JLG 24146.01-5 Dunn County Public Safety Center

Issued: November 4, 2025

ADDENDUM #: 01

1
M501
3/32" = 1'-0"
BASEMENT FIRE PLAN

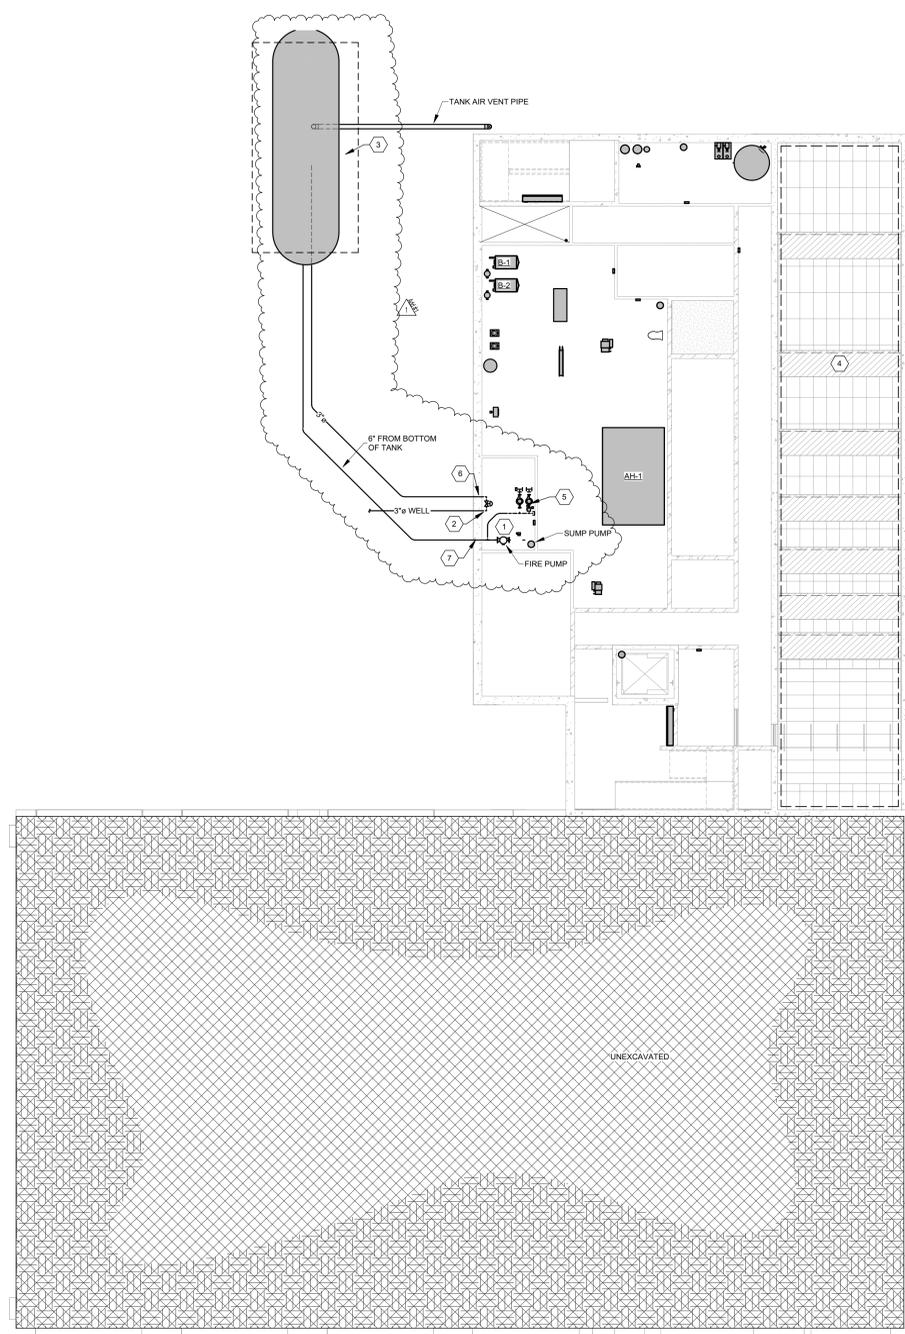
9. M405 – MECHANICAL SCHEDULES
 - Added Unit Heater – Hydronic schedule
10. M501 – FIRE PLAN
 - Drawing 1/M501: Reconfigured fire pump pit.

1
E200
Lighting Plan - Basement
1/8" = 1'-0"

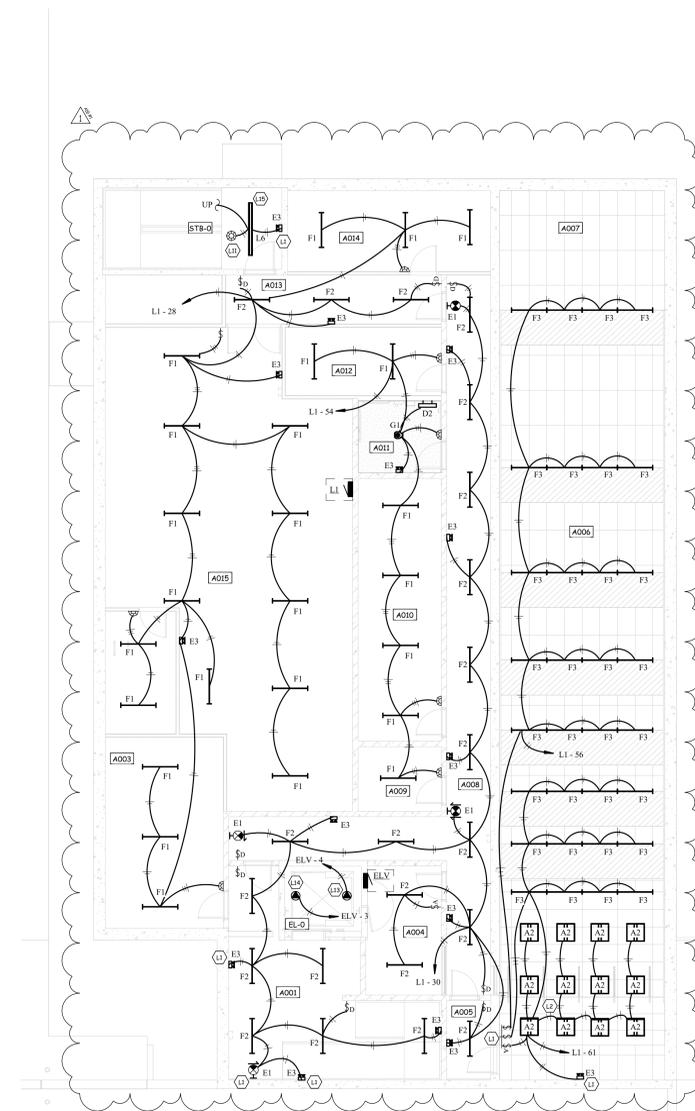
- 1. E200 – BASEMENT LIGHTING PLAN
 - o Drawing 1/E200: Added additional lighting control locations, added keynotes, and added fixtures.
- 2. E201 – LEVEL 1 LIGHTING PLAN
 - o Drawing 1/E201: Added additional lighting control locations, added keynotes, and added fixtures.
- 3. E202 – LEVEL 2 LIGHTING PLAN
 - o Drawing 1/E201: Added additional lighting control locations and added keynotes.
- 4. E203 – LIGHTING DETAIL
 - o Fixture Schedule: Updated part numbers, added Type DD1, and approved equals.
- 5. E300 – BASEMENT POWER PLAN
 - o Drawing 1/E300: Updated hand dryer location.
- 6. E301 – LEVEL 1 POWER PLAN
 - o Drawing 1/E301: Added additional receptacle locations and updated mounting heights.

1
E302
Power Plan - Level 2
1/8" = 1'-0"

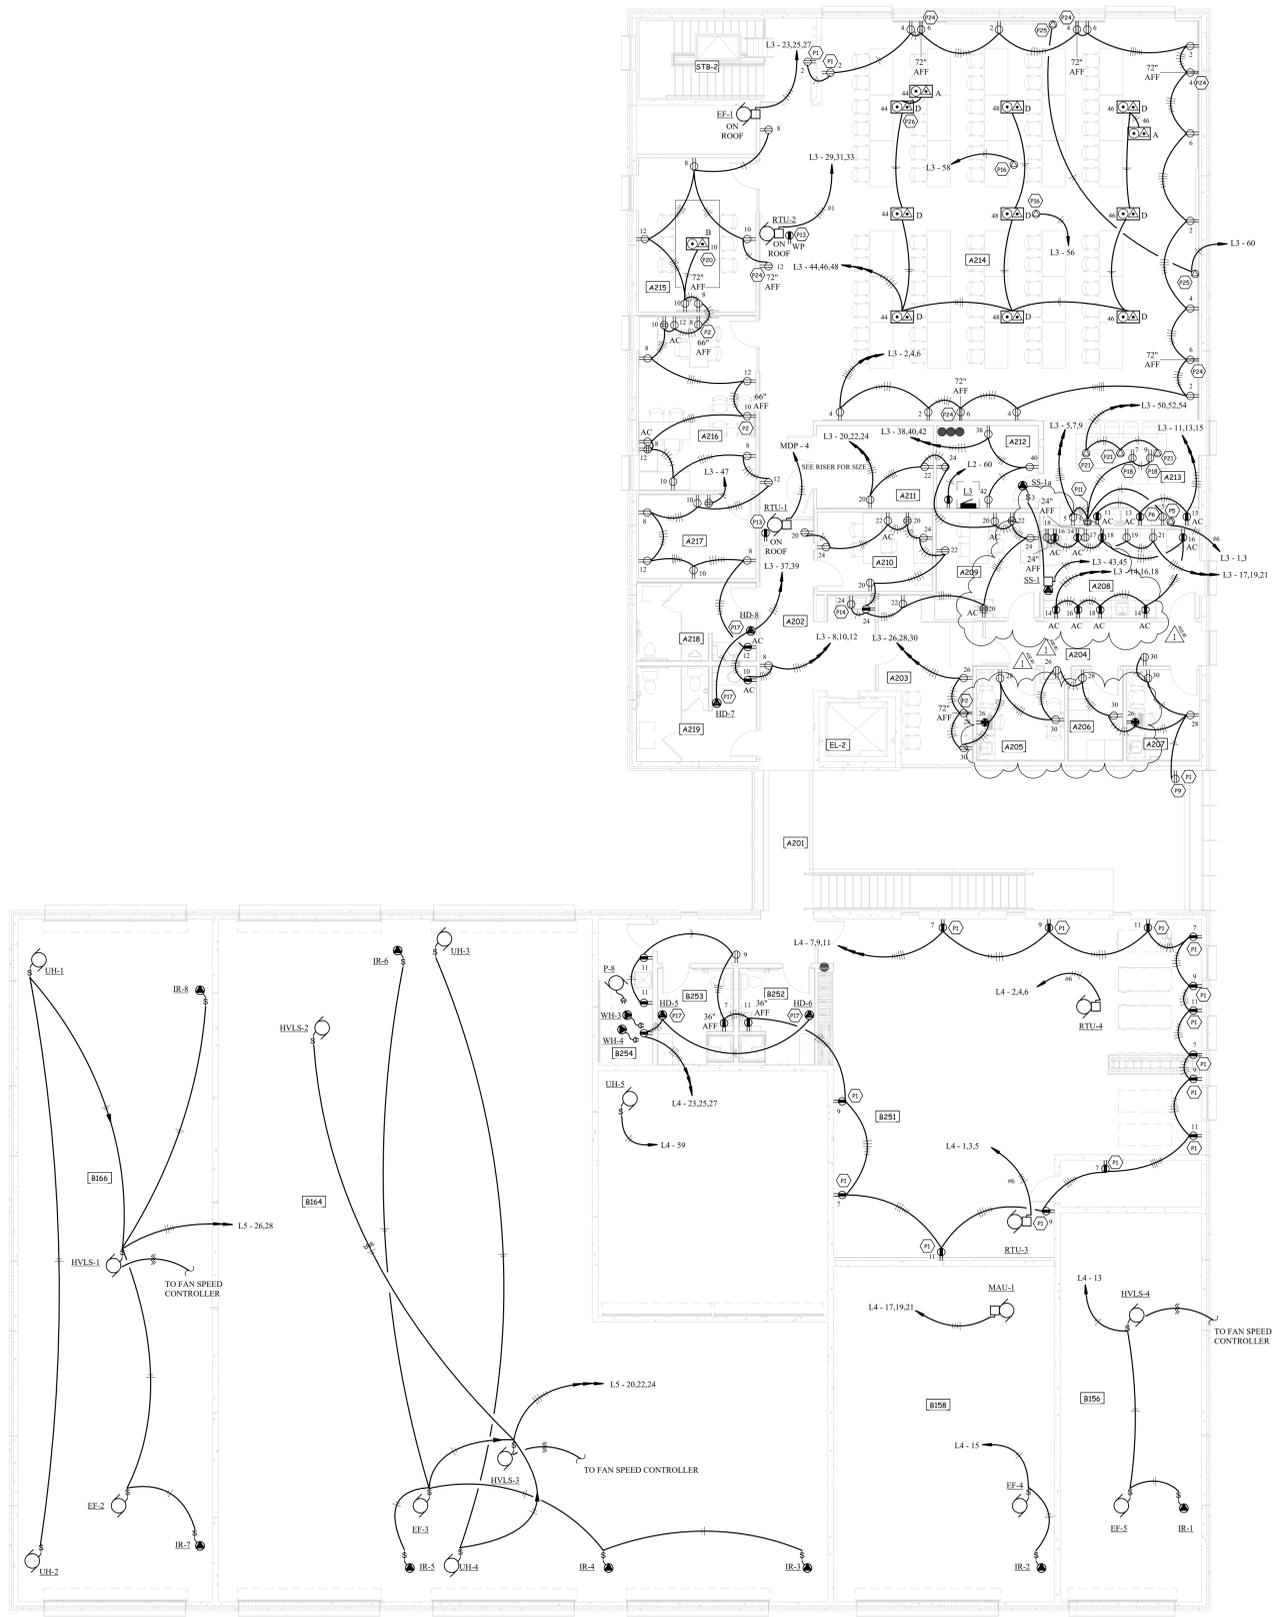
7. E302 – LEVEL 2 POWER PLAN
 - o Drawing 1/E302: Updated mounting heights.
